**Project:** GOLDEN GATE BEAUTIFICATION, M.S.T.U.  
**Project Manager:** Darryl Richards, r.l.a., P.S.D. – P.T.N.E. Dept.  
**Consultant:** McGee & Associates  
**Contractor:** Hannula Landscaping & Irrigation  
**Report Period:** FY 14-15, January 2015

**Location:** Coronado Pkwy. and Hunter Blvd.  
**Consultant's Representative:** Michael A. McGee, rla, isa  
**Contractor's Representative:** Dale Hannula  
**Report No.:** Four - FY 14-15

GOLDEN GATE BEAUTIFICATION, M.S.T.U.      **Location:** Coronado Pkwy. & Hunter Blvd.      **Report Period:** FY 14-15, January 2015      **Report No.:** Four

**Comment [MAM1]:**

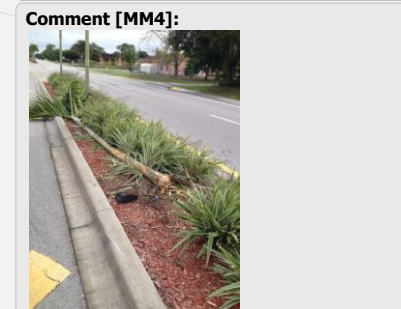
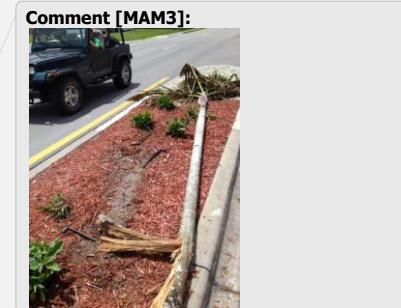
X	11	Hand remove grassy type weeds in Mimosa on west end of median and treat Dollar weeds.(photo)	M&A: 5/12/14 Continue hand removal until weeds are gone. M&A: 7/8/14 Grass and broadleaf type weeds still exist in Mimosa. Please have your pest control subcontractor continue to explore some over the top herbicides for the weeds. M&A: 8-13-14 Over the top herbicide to treat dollar weeds also killed Minosa. Spray dead area with contact herbicide to remove weeds and then provide count to replace with 1 gal. size plants. M&A: 9-10-14 Prune Mimosa behind back of curbing.
		X	16	At address 5291: Eight dead Coontie/Zamia need to be replaced. Please provide replacement plants at 3 gal. container size 16" ht./spr. One dwarf Bougainvillea 'Helen Johnson' plant is missing. Replant with 3 gal size.	Hannula 1/10/14: Estimate #14-0006 submitted. Staff approved 1/13/14.
		X	18	At address 5254: Five dead Coontie/Zamia need to be replaced. Please provide replacement plants at 3 gal. container size 16" ht./spr.	Hannula 1/10/14: Estimate #14-0006 submitted. Staff approved 1/13/14.

## GG MSTU Coronado - Hunter, Well Annual Water Use for 2014

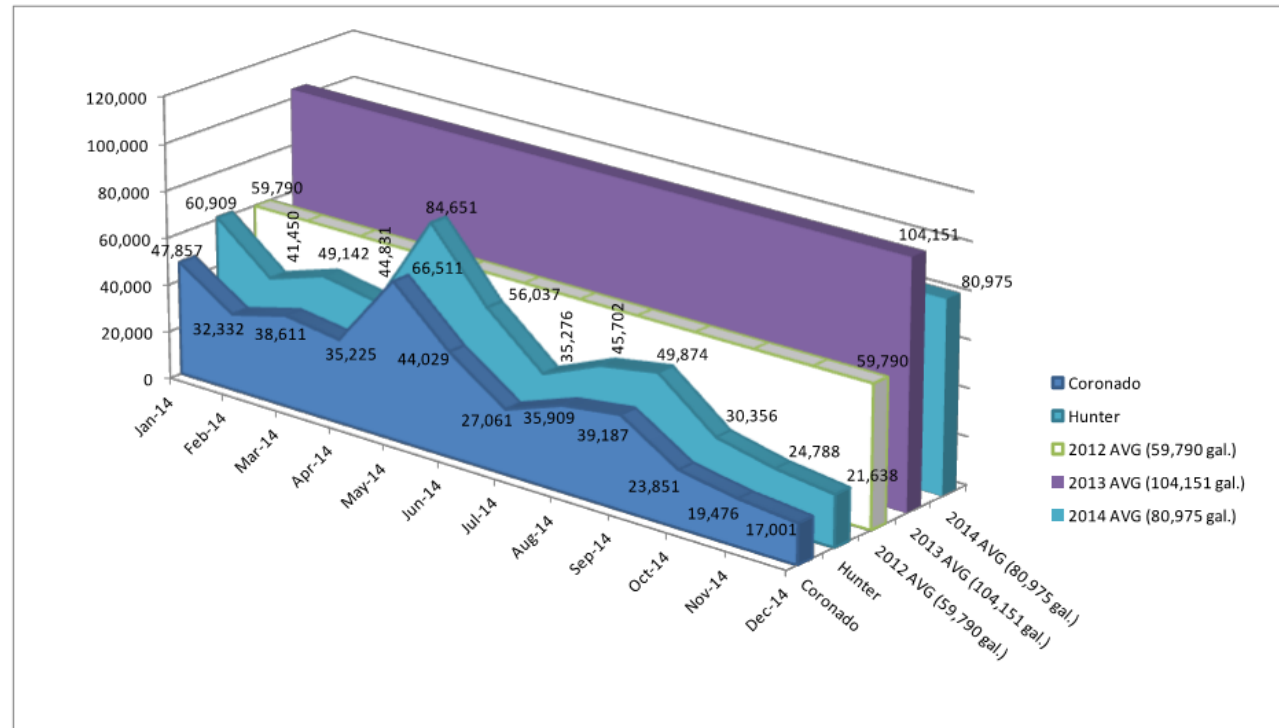
Recommended: Supplemental watering rate of .5 or less inches per week. One half inch per week equals 24,846 gallons per week or 99,384 gallons per month.

2014 total water use: 971,704 gallons or 19.66 inches of supplemental water pumped.
